Proposed Revisions to a Standard Plans Index

Originator:	Turley, Joshua	Index Number:	455-124
Date:	8/21/2024	Sheet Number(s):	2
E-mail:	Joshua.Turley@dot.state.fl.us	Index Title:	24" SQUARE CFRP & SS PRESTRESSED CONCRETE PILE

SS PRESTRESSED PILE DETAILS

STRAND PATTERN

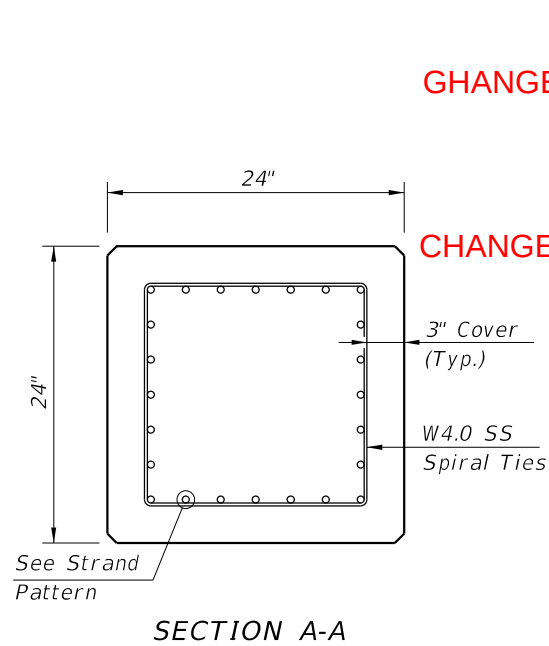
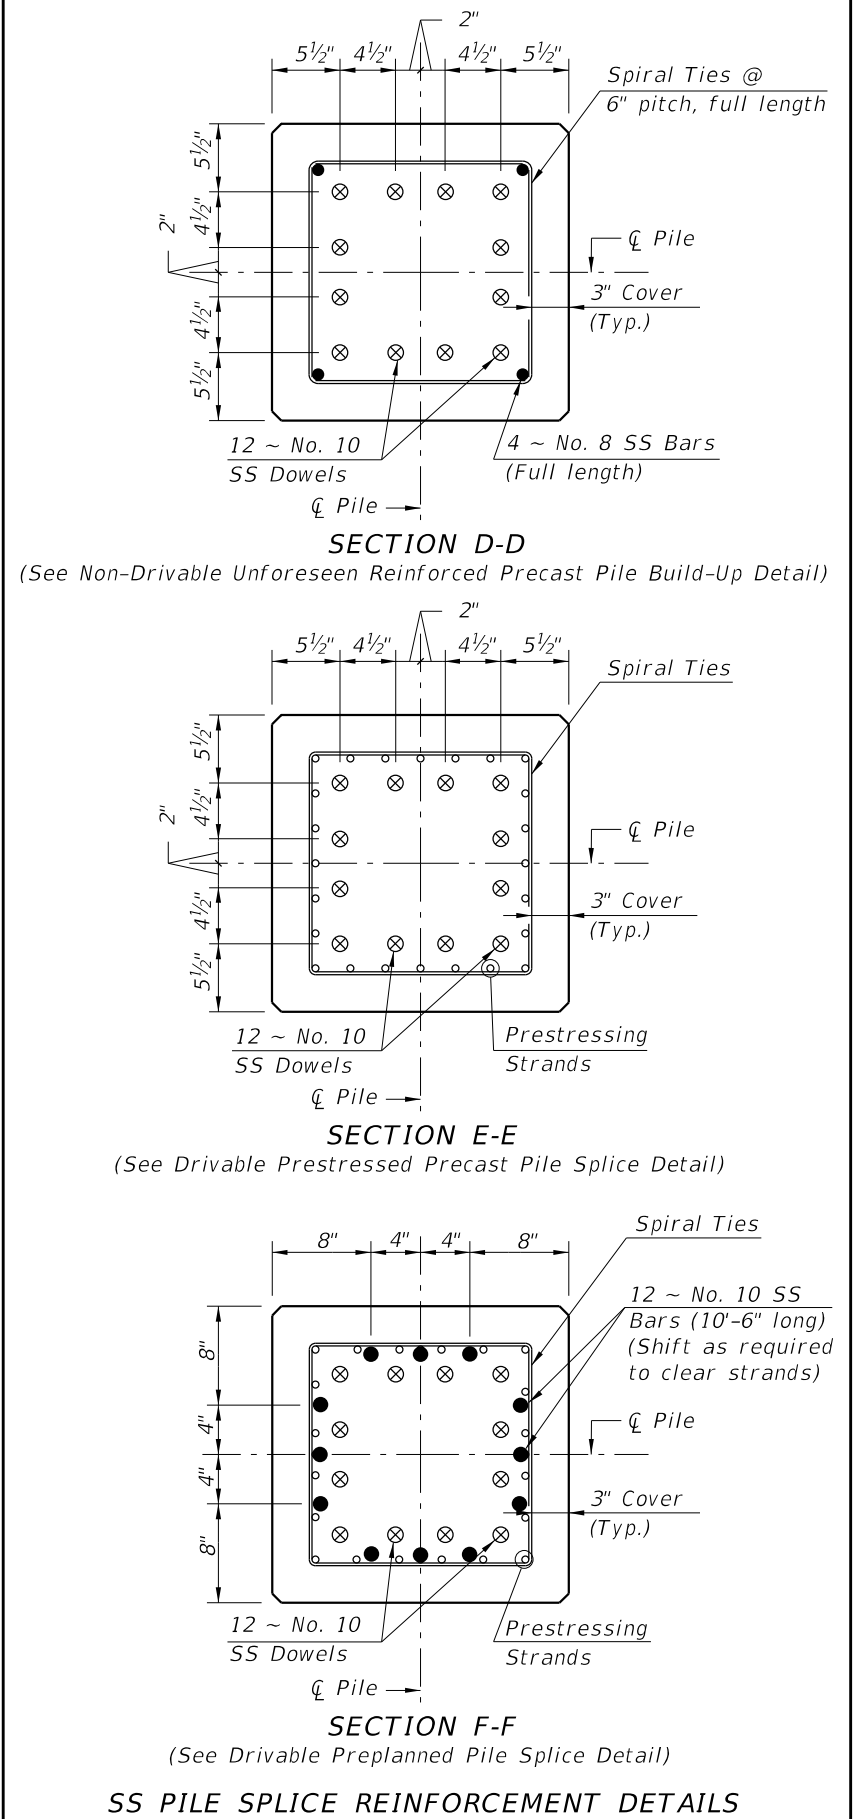
Sheet 2: Adjusted Strand Pattern diameter decimal places

CHANGED TO: 0.520"

CHANGED TO: 0.620"

This is a more accurate representation of the nominal diameter driven by the fact that the strands are fabricated in millimeters not inches.

STRAND PATTERN

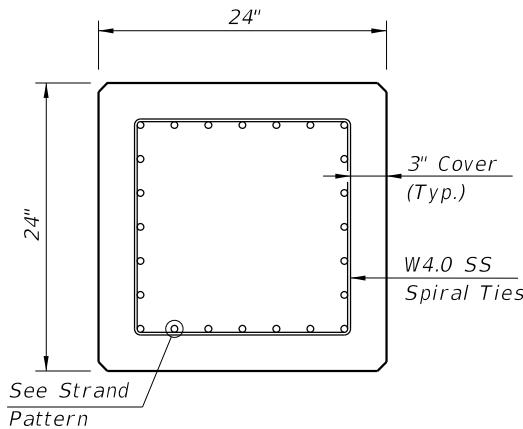
28 ~ 0.52" Ø, HSSS at 26 kips
20 ~ 0.62" Ø, HSSS at 35 kips
